## SERVICE INSTRUCTIONS

REFERENCE: FSA202212

SUBJECT: Retrofit of Megafuse

FSA TYPE: Recall

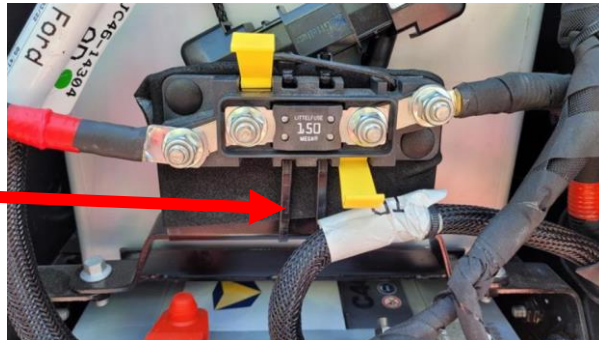
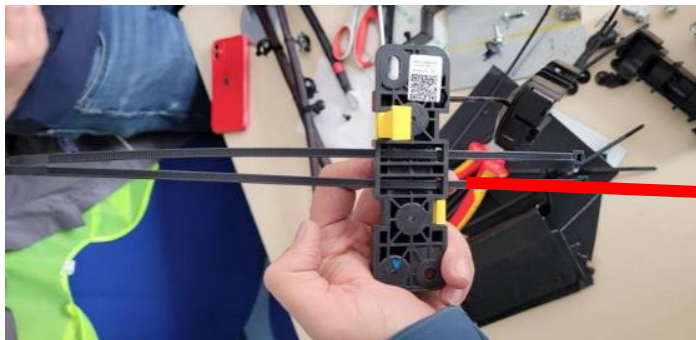
If there is no following tape on the bracket, the tape should be stickied on the bracket as in the photos below. The tape with excess from the sides should be cut from the side.

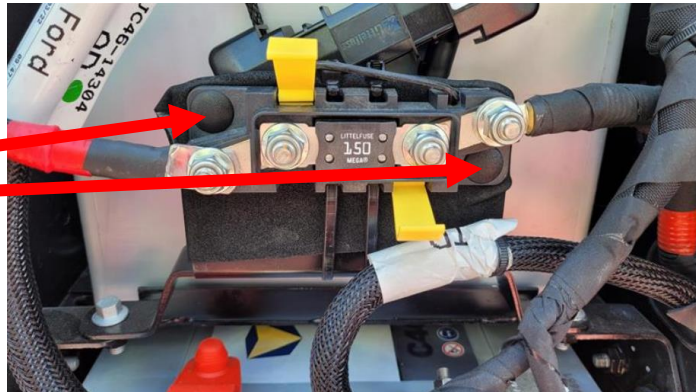
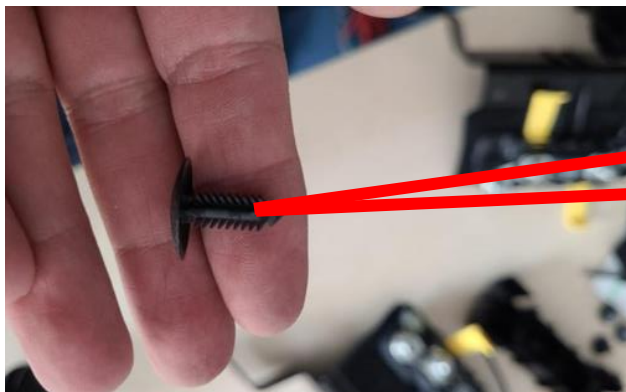
The strap should be passed through the megafuse strap area and the strap should be stickied together on the bracket as shown in the photo below.

The plastic push-pin should be mounted to the bolt via the sponge.

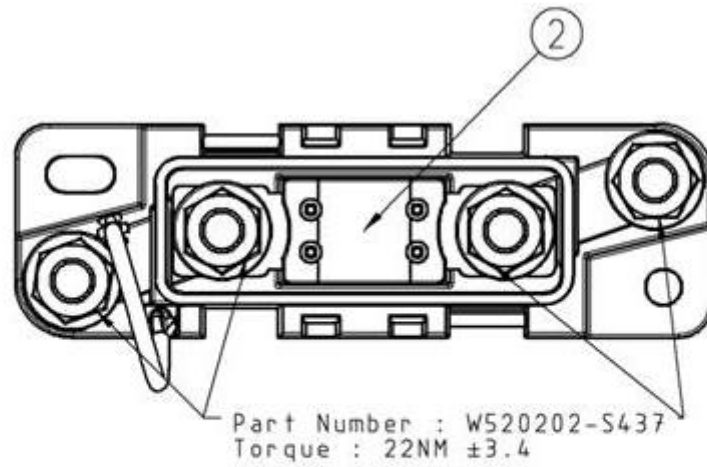
After the Mega Fuse Rework, it will be as in the photo below.

Finally, after the rework process is completed, the bolts marked below should be tightened again to **22NM**.

It should be noted that the harness isolation part should not be stuck between the eyelet and the bolt.
